PUBLIC HEARING  
**ZONING  
CHANGE**  
RR to R5A  
CASE # 15ZON1015  
DATE: AUGUST 20, 2015  
THURSDAY 1:00 PM  
514 WEST LIBERTY STREET  
OLD JAIL BUILDING  
THIS PROPOSAL MAY BE REVIEWED  
BY THE BOARD OF ZONING APPEALS  
AND DEVELOPMENT CENTER  
440 S. 104 STREET, SUITE 108  
HOUSTON, TEXAS **574-6230**

TO: David Wagner, Planner & LDT Committee  
FROM: Teena Halbig, Immediate Past President FFEA  
6505 Echo Trail  
Louisville, KY 40299  
502 267-6883  
DATE: 7-22-15  
RE: 15ZONE2015 (Brentwood Commons at 10509 Bardstown Bluff Road; rezoning from R-R to R5a request)

**10509 Bardstown Bluff – Proposed Zoning from RR to R-5A impacting Floyds Fork Creek** This proposal impacts all who visit the park and will be seen by all Jefferson County Residents as well as outside visitors. This proposal has major impact to Floyds Fork environment, the future Rental Residents, as well as joining properties.

**Major proposal to move the 100 Year Floodplain**

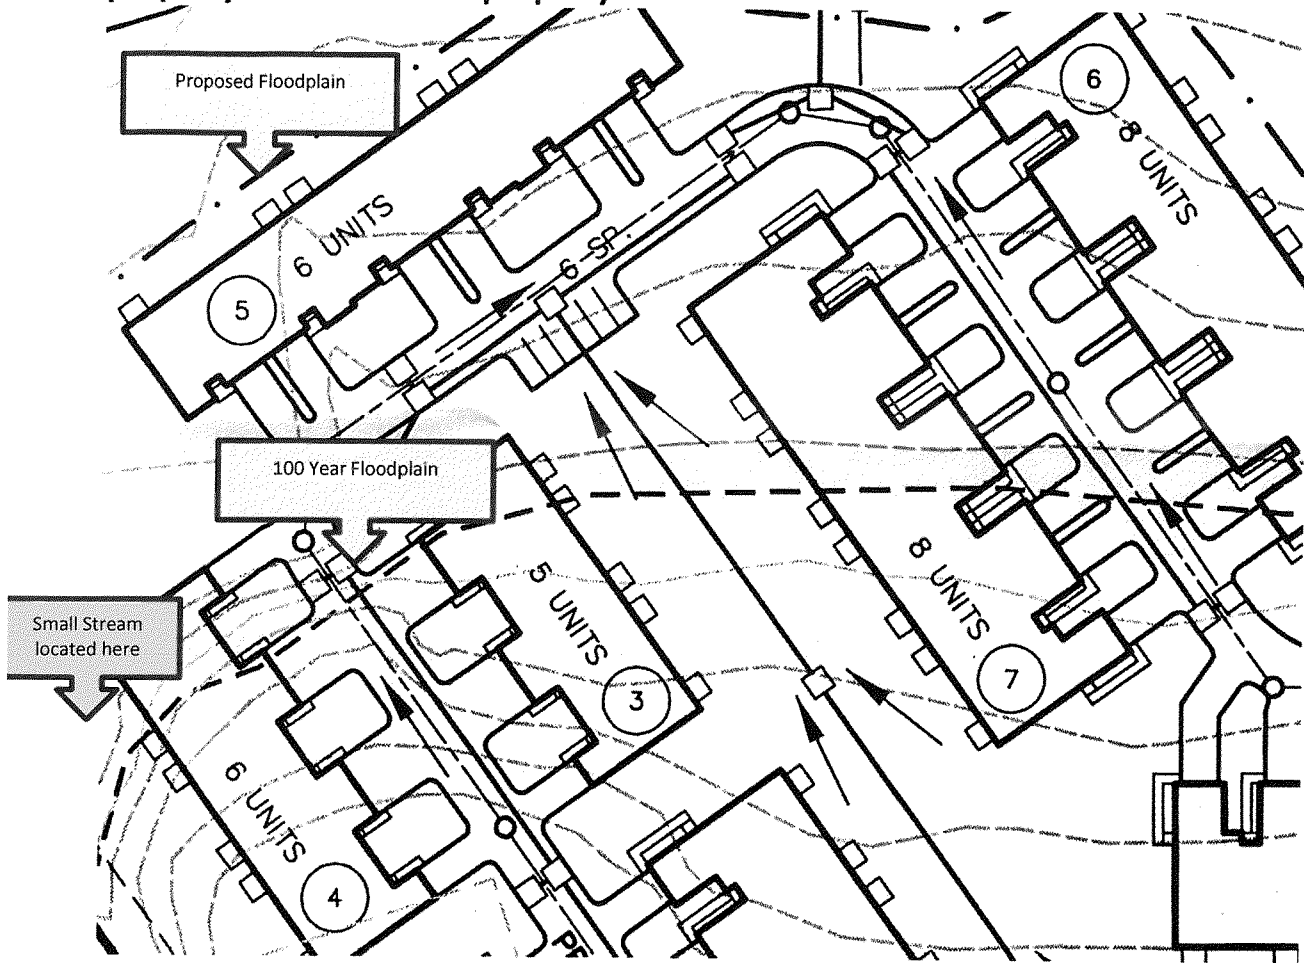
#3, 4, 5, 6 and 7 buildings, 33 Apartments to be built in flood area. Flooding has occurred in 1997, 2009, 2011, 2013, and 2015. Flooding is more frequent as subdivisions are built closer to the Floyds Fork. Yellow note displays location of the small stream running from the 10505 property onto the 10509 property.

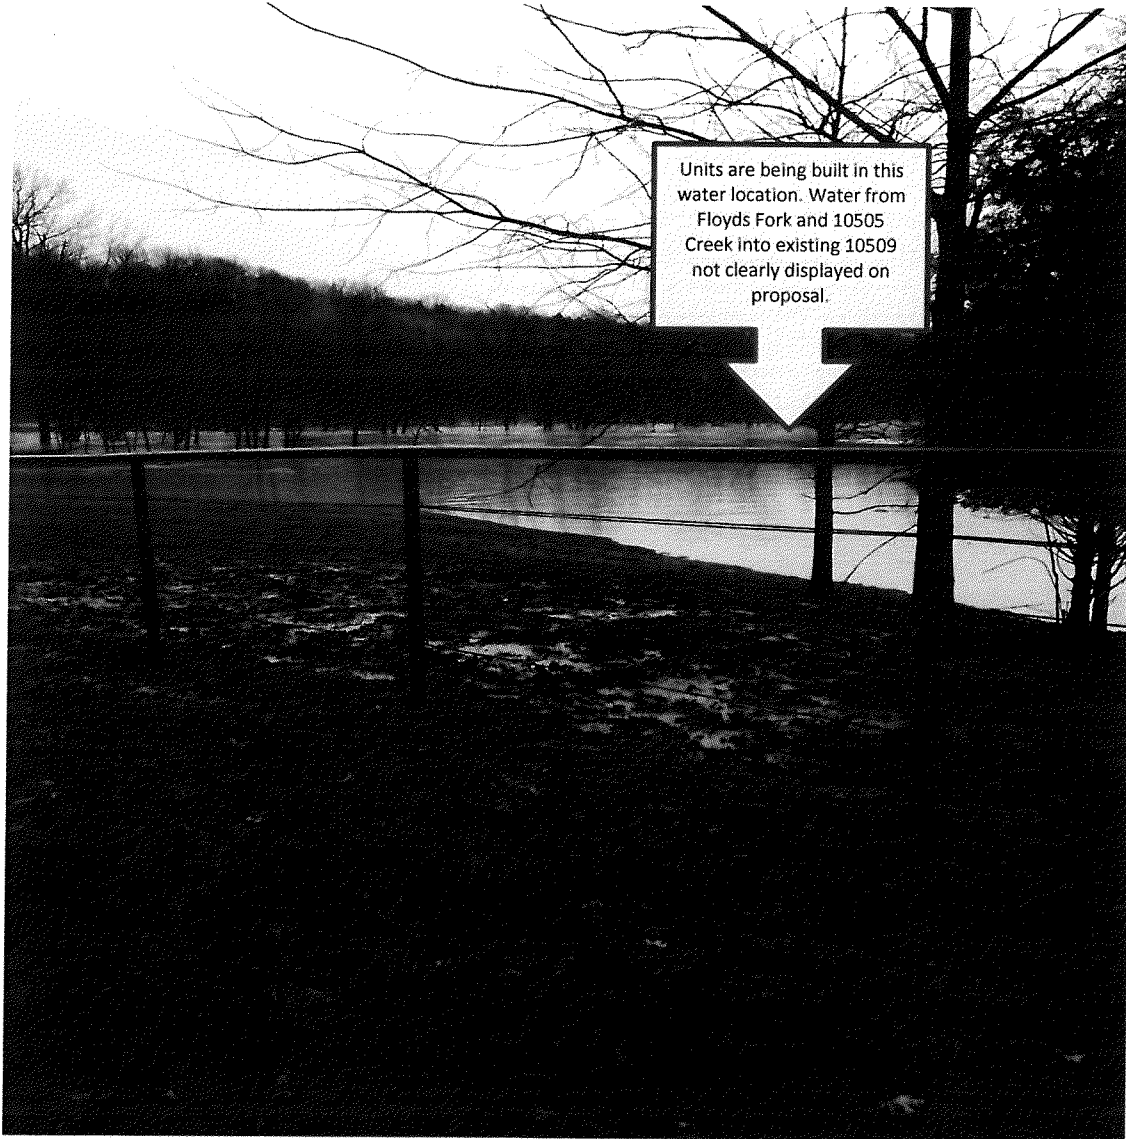
Below is an April 2015 picture of the small stream (not so small during flooding) on the 10509 property.

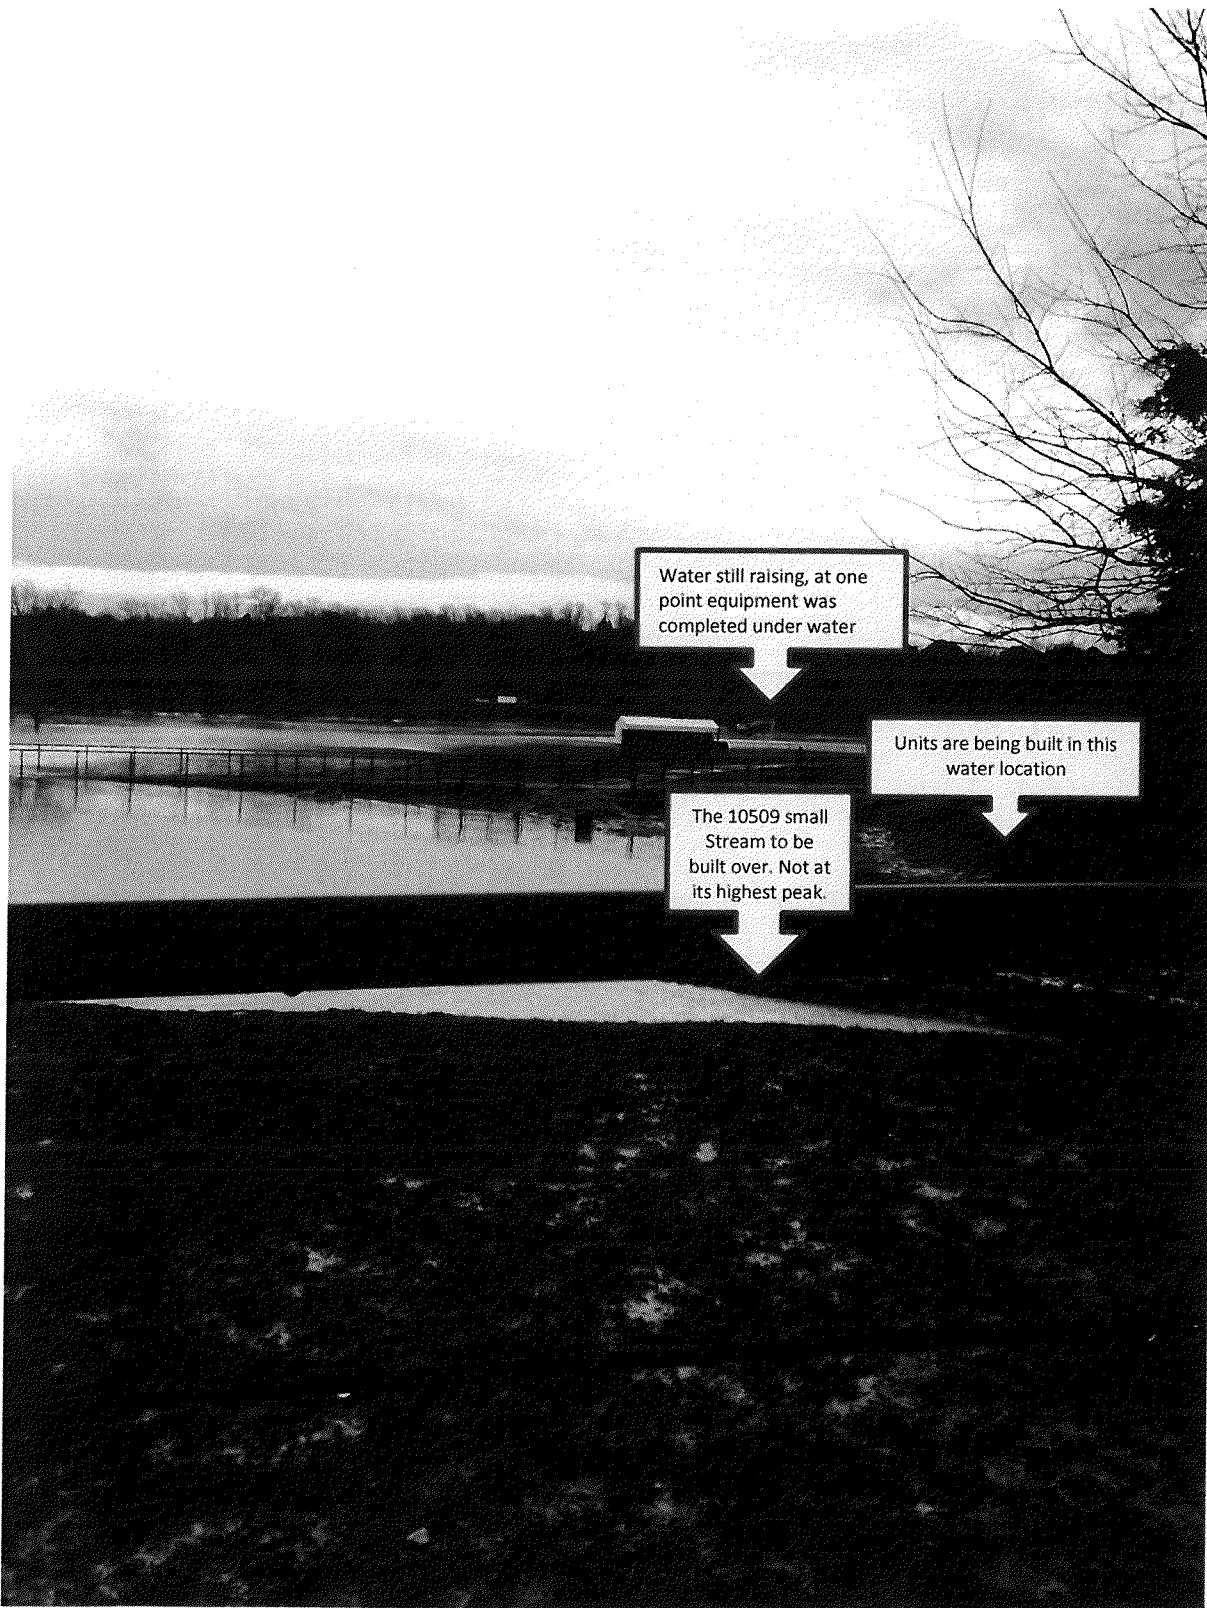
Below April 2015 picture is of the small stream on the 10509 property. The Parkland Bridge is in the background.

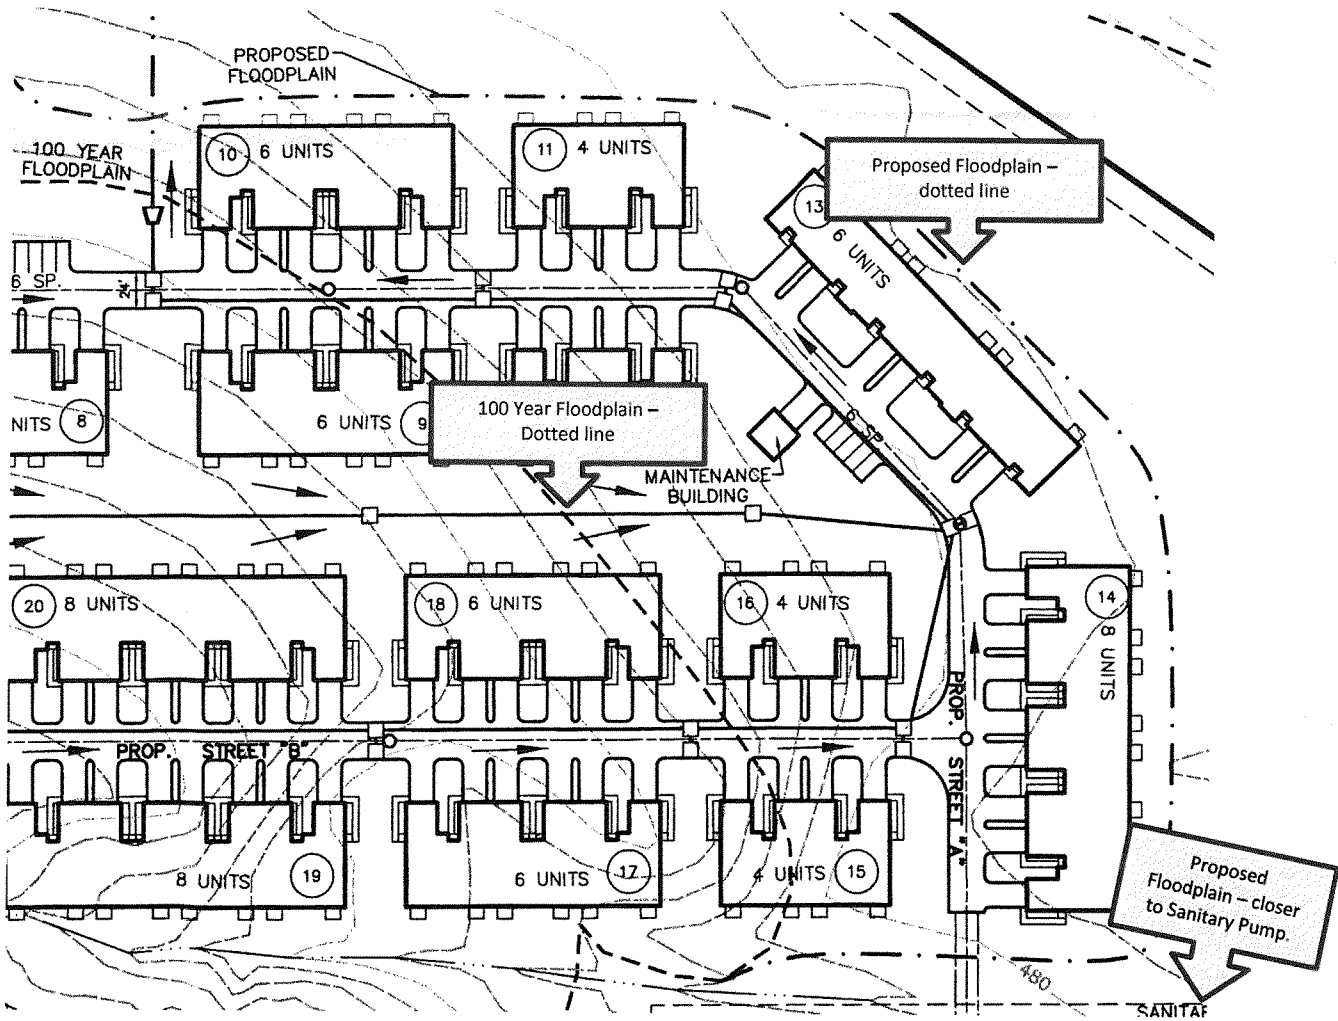
Large distance between the 100 Year Floodplain to the Proposed Floodplain. For approximately the last 20 years every 5 years the property has been flood past the 100 Year Floodplain.

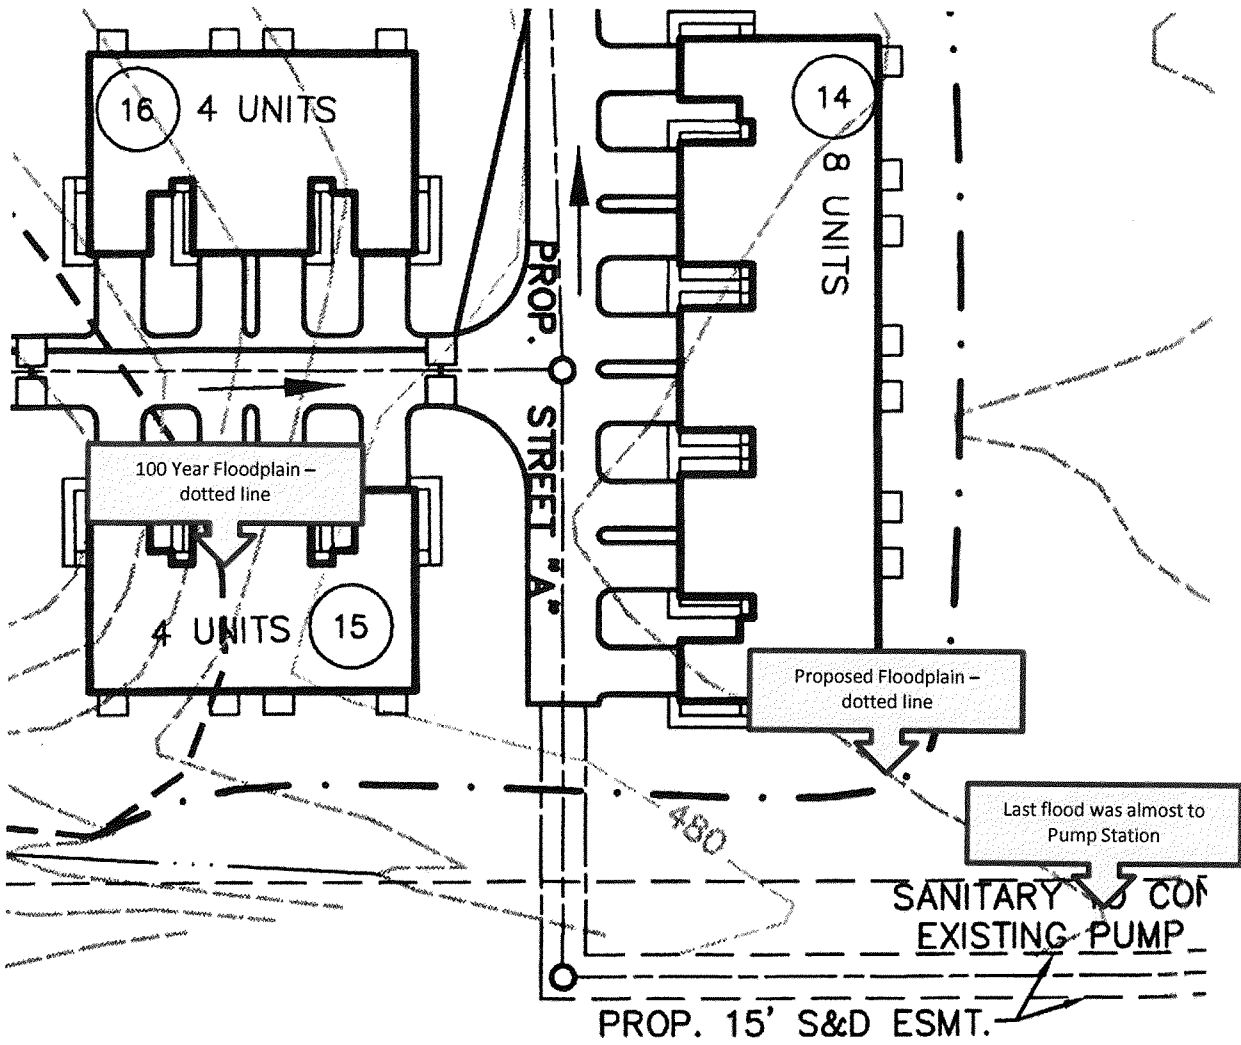
1. Did MSD take in consideration the proposed Floodplain move impacting the Sanitary Pump Station? If so, what is the plan to secure the Sanitary Pump Station? The last flooding in April was dangerously close to this Pump Station, planning has the floodplain closer to the Pump Station. (Provided April 2015 pictures)

Proposed Floodplain is closer to the Sanitary Pump Station than the 100 Floodplain. 2015 Flood came dangerously close to the Pump Station, now they are proposing a closer Floodplain.

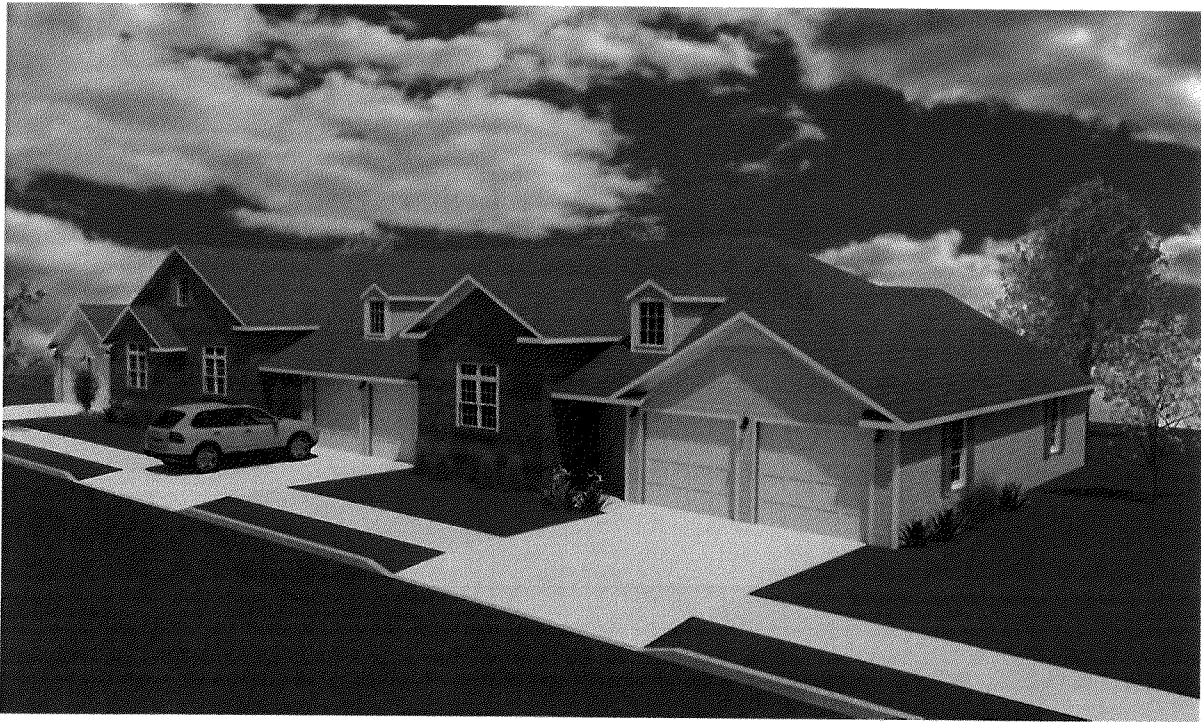
Example of what will be built – backside is not shown in any of the pictures. The backside will NOT be brick. If plans are approved requesting Brick to keep with the character of other units within the area and to be more appealing to the eye as well as being able to stand up to flooding.

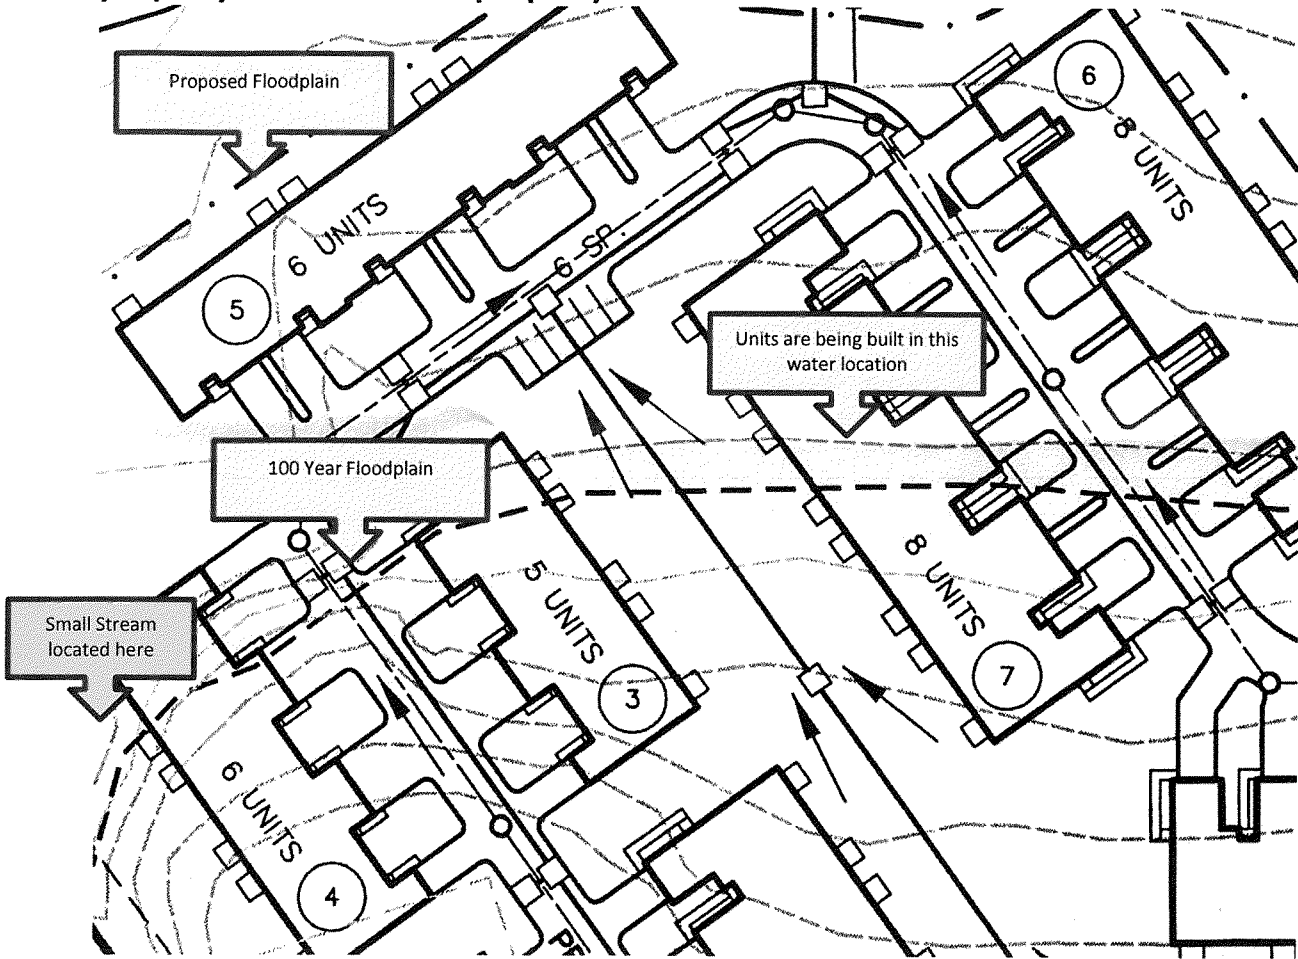
#3, 4, 5, 6 and 7 buildings, 33 Apartments to be built in flood area. Flooding has occurred in 1997, 2009, 2011, 2013, and 2015. Flooding is more frequent as subdivisions are built closer to the Floyds Fork. Yellow note displays location of the small stream running from the 10505 property onto the 10509 property.

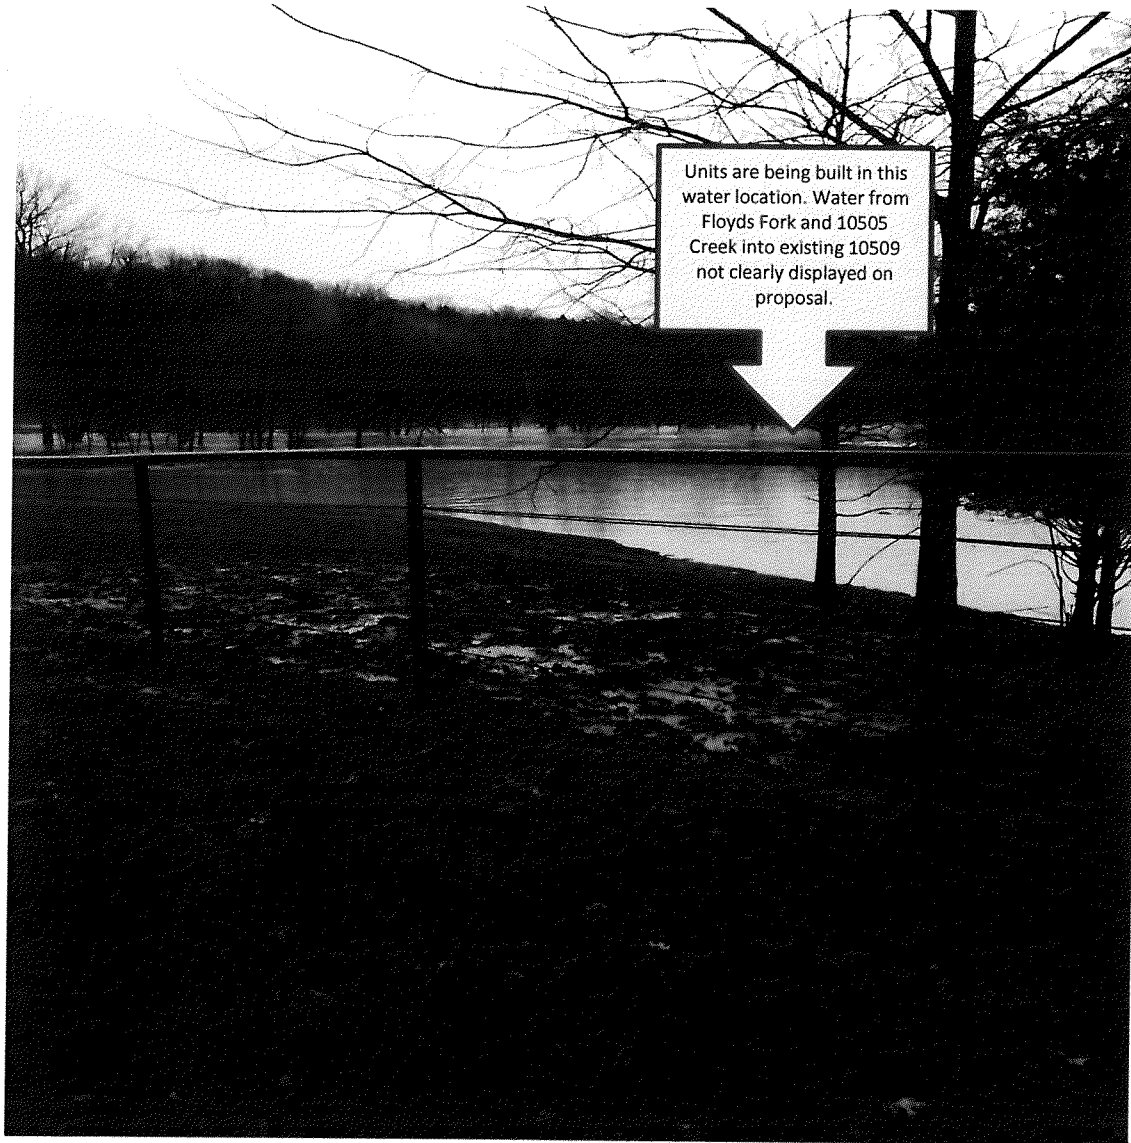
Below is an April 2015 picture of the small stream (not so small during flooding) on the 10509 property.
